**PUBLIC HEARING MEMORANDUM**

Public Hearing Date: January 8, 2019  
Land Use Action Date: March 26, 2019  
City Council Action Date: April 1, 2019  
90-Day Expiration Date: April 8, 2019

SUBJECT: **Petition #564-18**, petition for SPECIAL PERMIT/SITE PLAN APPROVAL to allow a three-story, multi-family structure, 35.5' in height containing nine dwelling units, to allow a reduction in the parking requirement to one stall per unit, to allow a retaining wall greater than four feet within the setback, to allow off-site parking and to allow waivers to the requirements of parking facilities containing more than five stalls, in Ward, 6, Newton Centre, at **39 Herrick Road**, Section 61 Block 35 Lot 07, containing a lot area of approximately 12, 979 sq. ft. of land in a district zoned BUSINESS USE 1. Ref: §7.3.3, §7.4, §4.4.1, §4.1.2.B.3, §5.1.4, §5.1.13, §5.1.6.A, §5.1.6.B, §5.4.2.B, §5.1.8.A, §5.1.8.B.5, §5.1.8.C.2, §5.1.8.D.1, §5.1.9.A, §5.1.10, of the City of Newton Rev Zoning Ord, 2015.

**39 Herrick Road**

**View from MBTA Tracks**

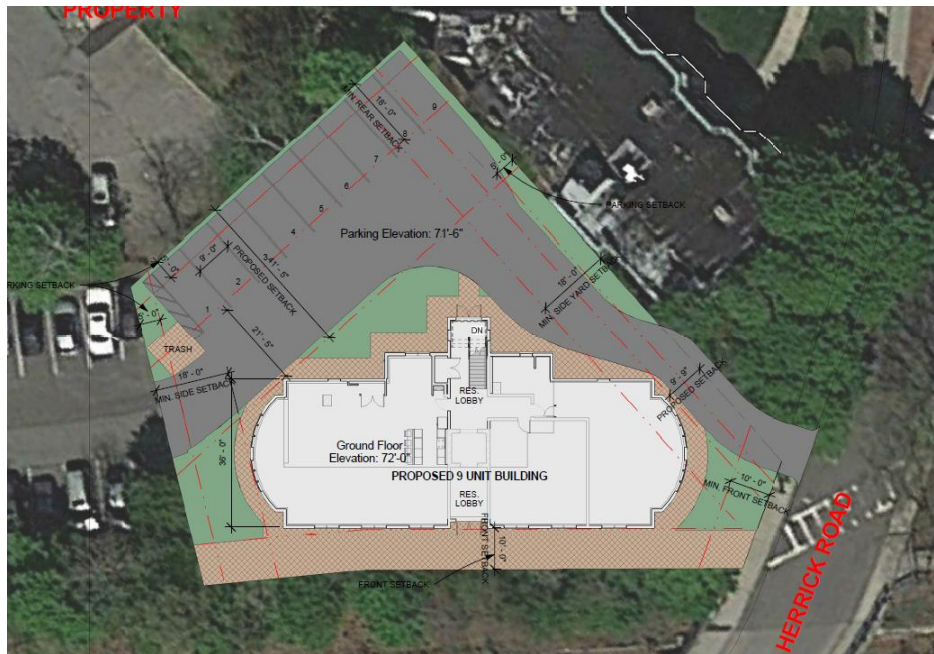
As proposed, the structure is oriented towards the MBTA tracks to the south and to the surface parking facility to the north, not Herrick Road. This design is unchanged from previous petitions that included a below grade garage. These earlier designs that included the restaurant or the office space, featured a front door from Herrick Road for pedestrians. The Planning Department would like to see a front door featured on the Herrick Road façade and suggests the petitioner consider redesigning the structure to feature a prominent pedestrian entrance.

The driveway location along Herrick Road is partially dictated by the location of an existing light pole. The Planning Department informed the petitioner that the Department of Public Works would consider the petitioner relocating the existing light pole to reduce the likelihood of the pole being hit by a vehicle. The Planning Department believes the petitioner should seize upon this flexibility to create a stronger façade facing Herrick Road and suggests the petitioner appear before the Urban Design Commission to discuss the site design and building orientation. Additionally, relocating the light pole may allow for the retention of the metered stall on Herrick Road.

As proposed, much of the lot will be consumed by impervious surfaces to allow for access and parking. This is in part due to the site's constraints and the orientation of the proposed structure. Such a design does not create any open space for the building's tenants, orients the building towards surface parking and the MBTA tracks, relies on egress through the Cypress Street Municipal lot, and creates a narrow drive aisle that would serve as both ingress and egress if the license over the Cypress Street Municipal Lot was ever revoked. For these reasons, the Planning Department recommends the petitioner redesign the project to reorient the building, improve access, reduce impervious area, and increase useable open space.
